City of Pompano Beach

Staff Report

File #: LN-575

VARIANCE - BAYVIEW OF POMPANO

Surrounding Multifamily Properties

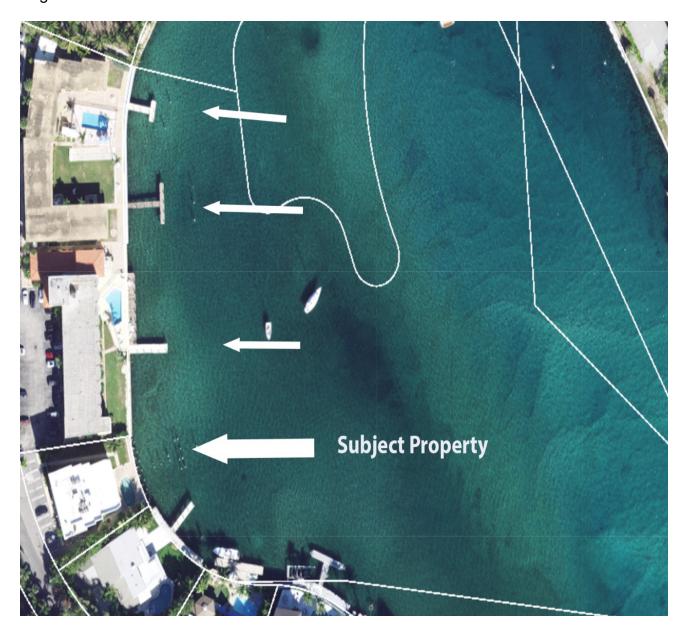
None, in fact the structure is in conformance with the surrounding multifamily properties – see the map page 4.
